Submission of Report on the Current Seismic Safety and Reinforcement of the Reactor Buildings at Fukushima Daiichi Nuclear Power Station to the Nuclear Regulation Authority (No.1) (Supplement) (Revision 2) to the Nuclear Regulation Authority

< Reference > December 25, 2012
Tokyo Electric Power Company

Unit 4 Reactor Building
Heat conduction
analysis model

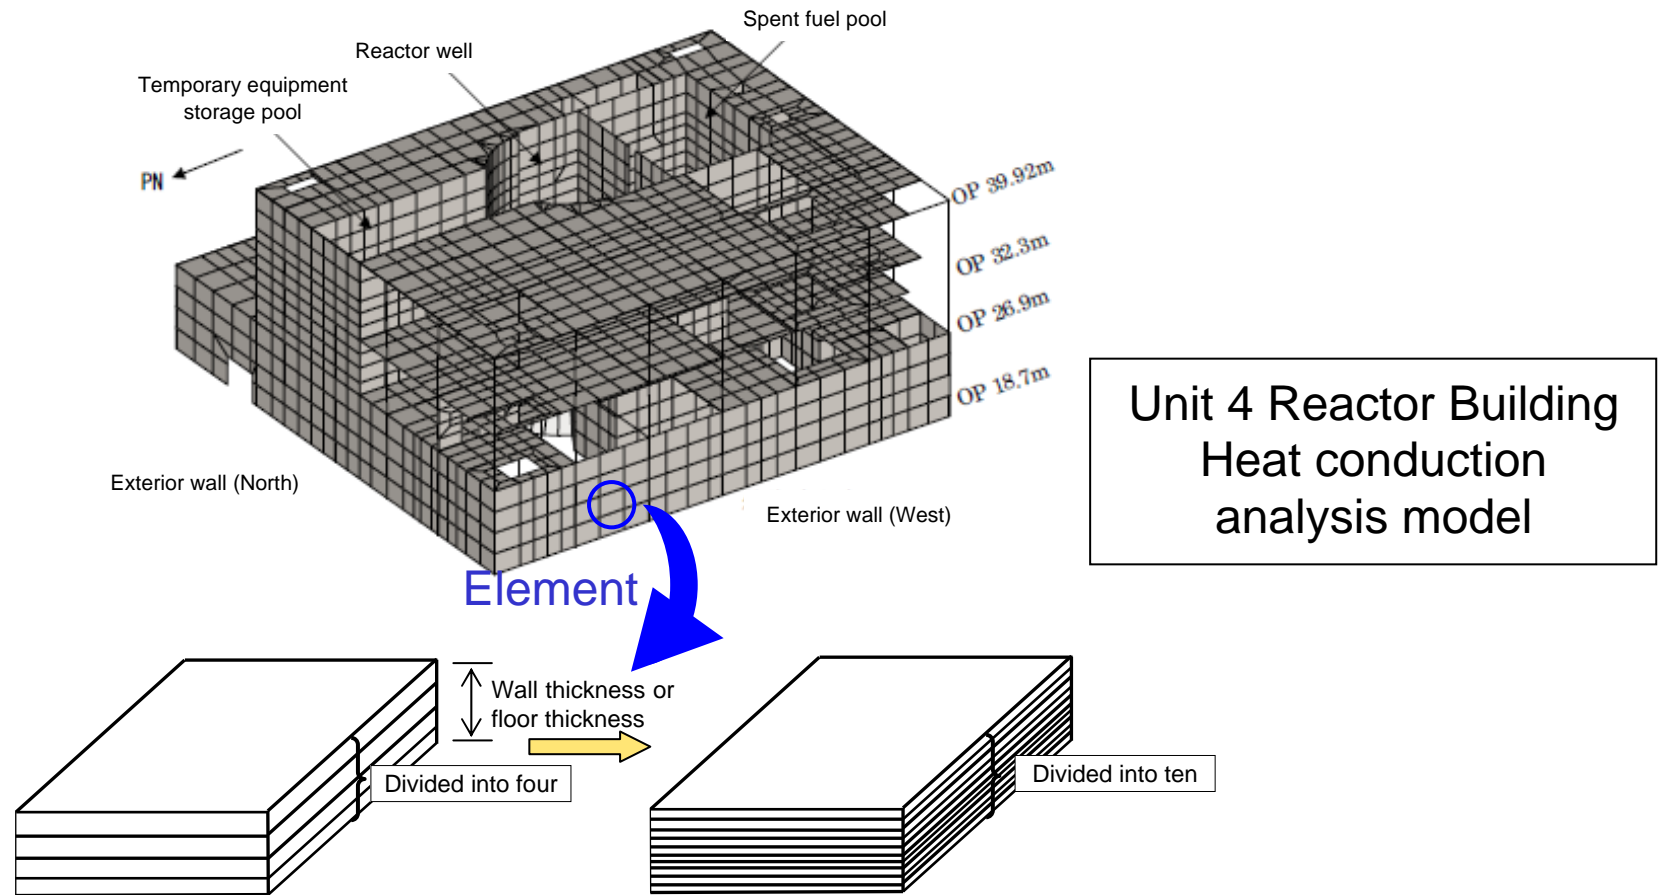
The element is divided into ten instead of four.

The above indicates locations (elements) where the ratio of the "concrete/rebar distortion due to axial force and bending moment" and the "out-of-plane shear force" (margin) is the largest, which have been changed before and after the revision.

* "Margin" is now indicated as "ratio". The calculation is done in the same way and the judgment is "OK" as long as the result is below 1.

⇒ There is a sufficient margin from the distortion and stress generated to the evaluation criteria.
